**LORETO NORMANHURST
BOARDING HOUSE**
91-93 PENNANT HILLS ROAD
NORMANHURST, NSW 2076

SITE ANALYSIS

DA1003 A

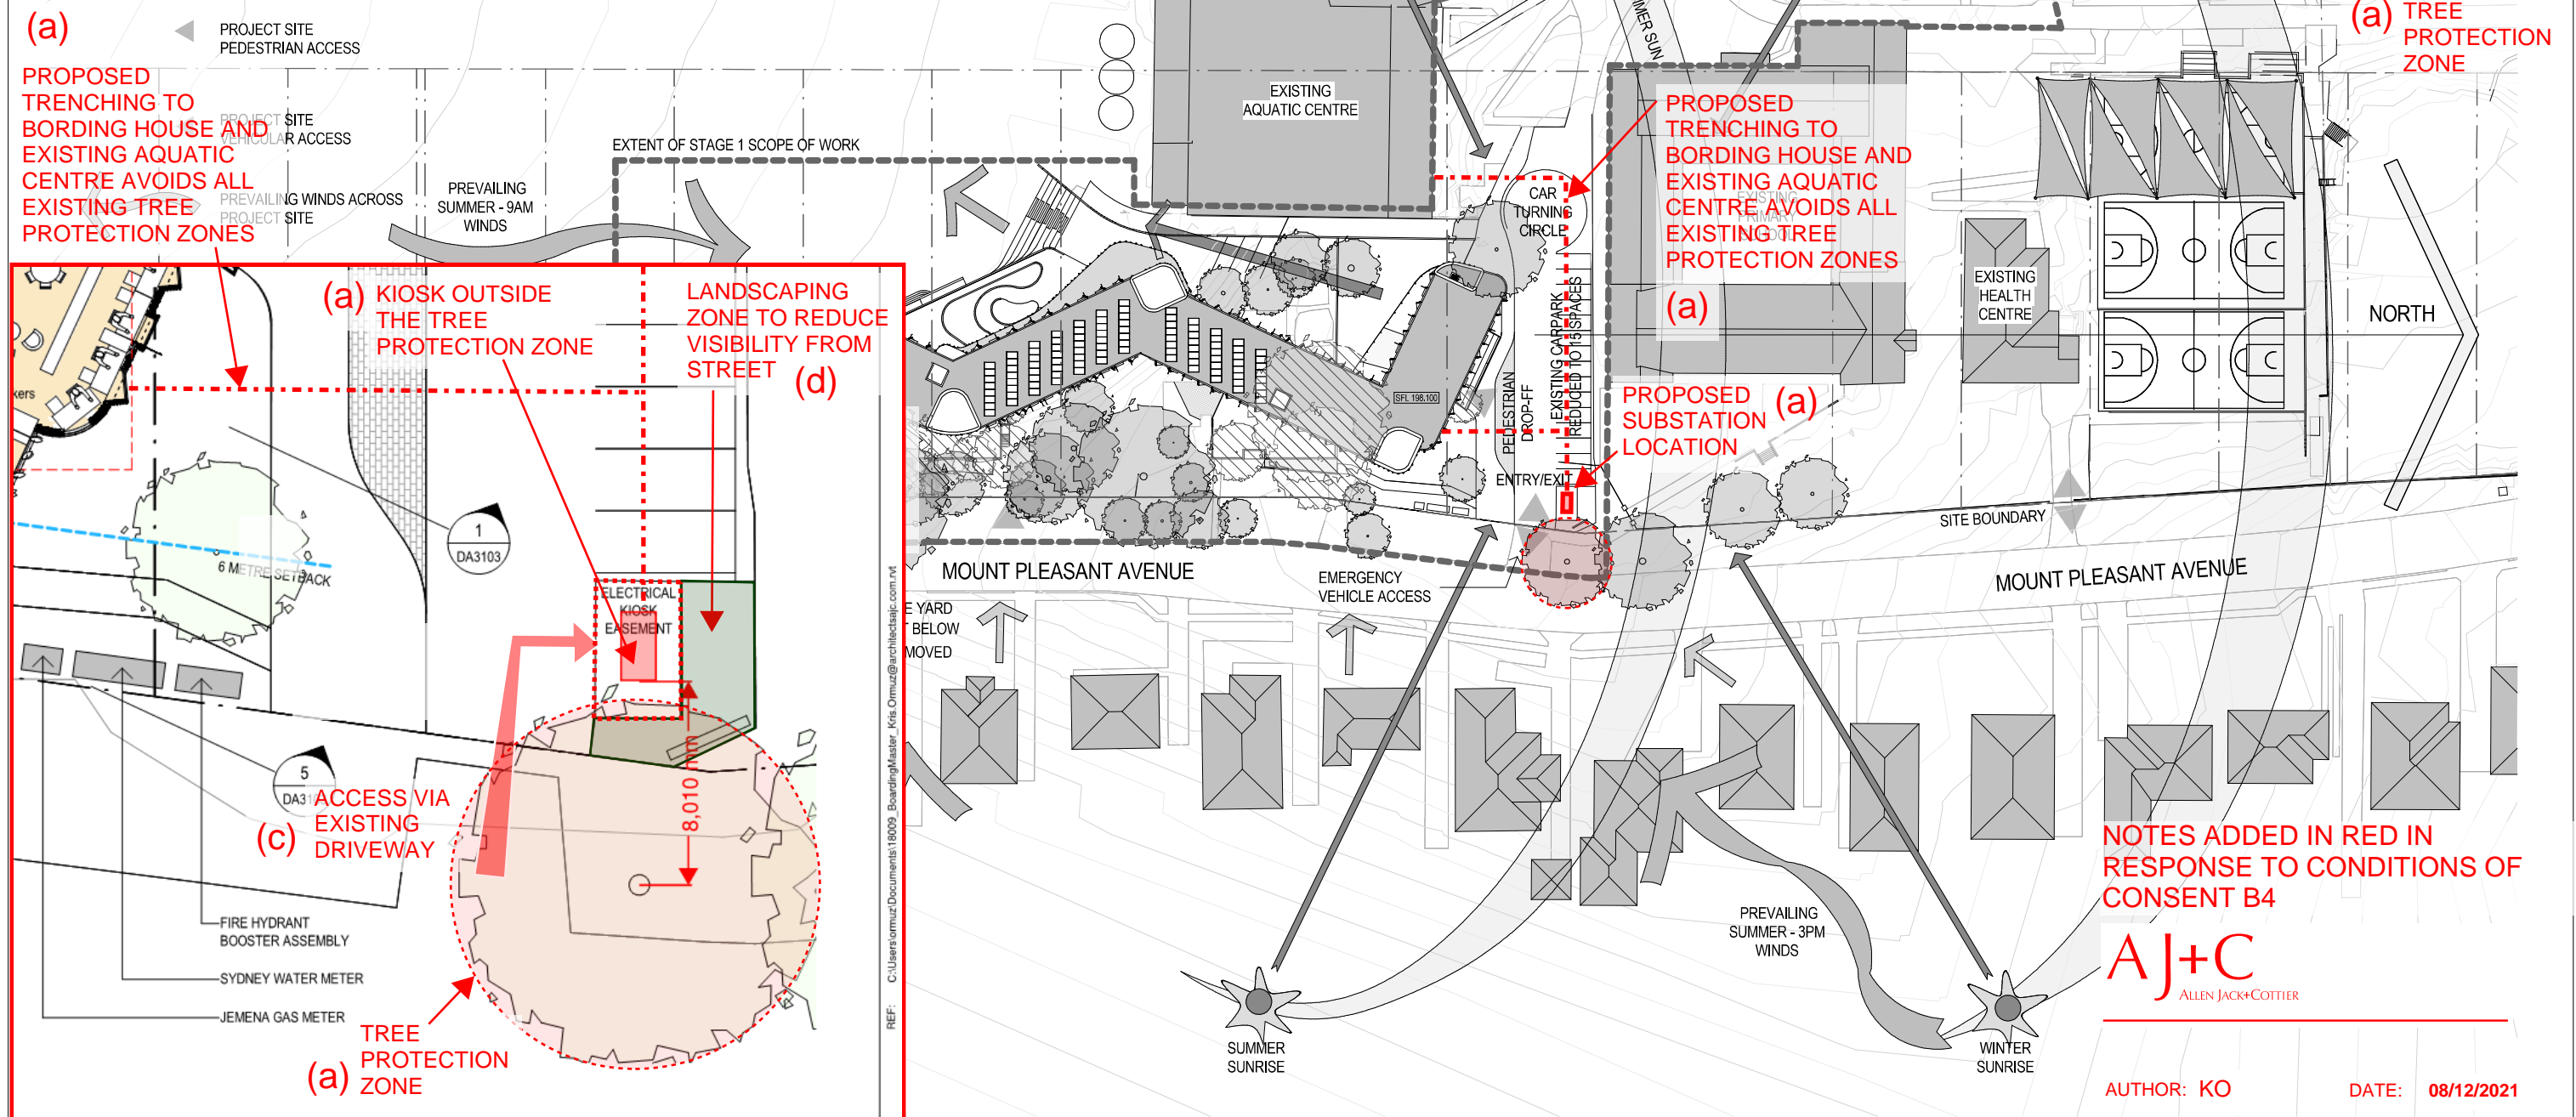
B4. Prior to the issue of any construction certificate for Stage 1, the Applicant must submit detailed plans of the electrical stand-alone substation to the satisfaction of the Planning Secretary. The plans must:

- (a) demonstrate that service connections, cabling or associated works would not be located within Tree Protection Zone or Structural Root Zone of any existing trees;
- (b) confirm appropriate tree protection measures to be implemented during construction (if required); (b) NO SUBSTATION RELATED WORKS ARE PROPOSED NEAR EXISTING TREES
- (c) demonstrate that the substation front is accessed from the existing Primary School car park driveway and does not include a new separate driveway connected to Mount Pleasant Avenue; and
- (d) include details of landscaping around the substation to visually screen / reduce the visibility of the structure from Mount Pleasant Avenue.
